ALERT SERVICE BULLETIN

505-24-40

MODEL AFFECTED: 505

SUBJECT: TAIL ROTOR SEGMENTED DRIVESHAFT ASSEMBLIES, ONE-TIME INSPECTION OF.

Figure 1 – Tail Rotor Segmented Driveshaft Assembly

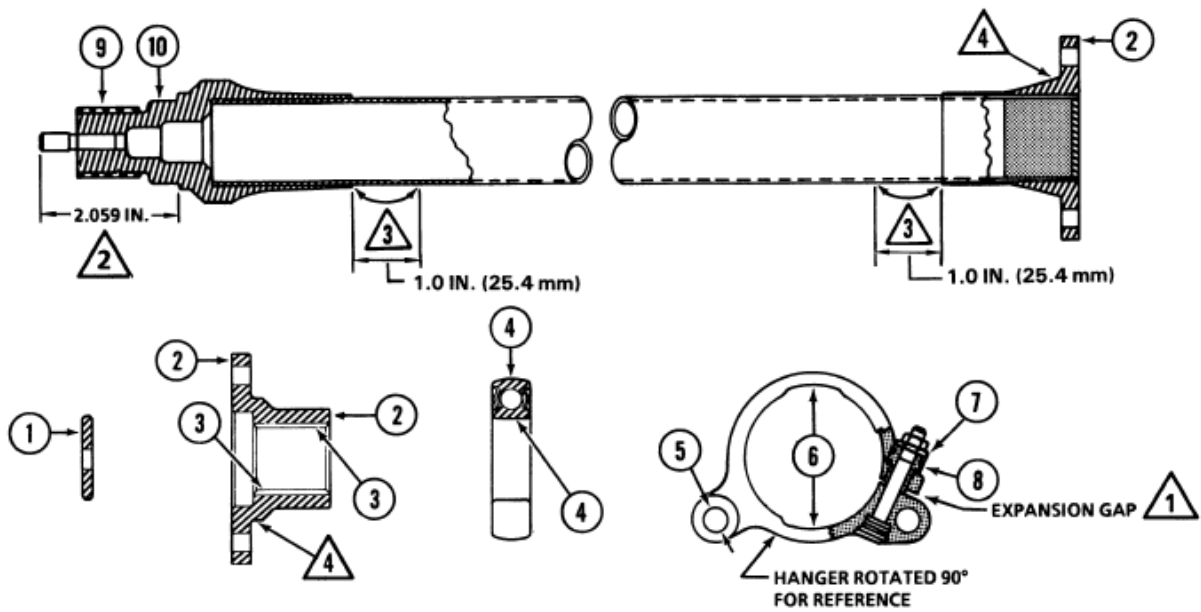
Bell has received reports of looseness of the splined adapters on the tail rotor segment driveshaft assembly. The investigation noted that the retaining nut holding the splined adapter to the driveshaft was found with less than the required torque.

This Alert Service Bulletin (ASB) is being released to require a one-time inspection and re-torque of the splined adapter retaining hardware.

8. Check the tail rotor segmented driveshaft assembly splined adapters (4) for any noticeable radial or axial (fore and aft) play between the splined adapter (4) and the driveshaft (5) for all five locations (Figure 1, View A).

- a. If there is no radial or axial play noted, perform the following:
 - (1) Remove any torque seal lacquer (C-049) that may be applied to nut (1) on all five of the tail rotor segmented driveshaft assemblies.

- (2) Unseat the nut (1) by loosening the nut by $\frac{1}{2}$ to 1 turn (BHT-ALL-SPM, Chapter 2) at each of the five tail rotor segmented driveshaft assemblies.

- (3) Measure the tare torque of the nut (1) using a dial indicator torque wrench.
 - (a) If the nut (1) tare torque meets the minimum tare torque of 3.5 inch-pounds (0.4 Nm), go to step 8.a.(4).

- (b) If the nut (1) tare torque is less than 3.5 inch-pounds (0.4 Nm), replace the nut with a serviceable nut and repeat step 8.a.(3).
 - (4) Torque the nut (1) 30 to 50 inch-pounds (3.4 to 5.6 Nm) plus the tare torque measured in step 8.a.(3).

- (5) Apply torque seal lacquer (C-049) across threads of the stud of driveshaft (5), nut (1), washer (2), and plate (3). Go to step 9.
 - b. If radial or axial play is noted, perform the following:
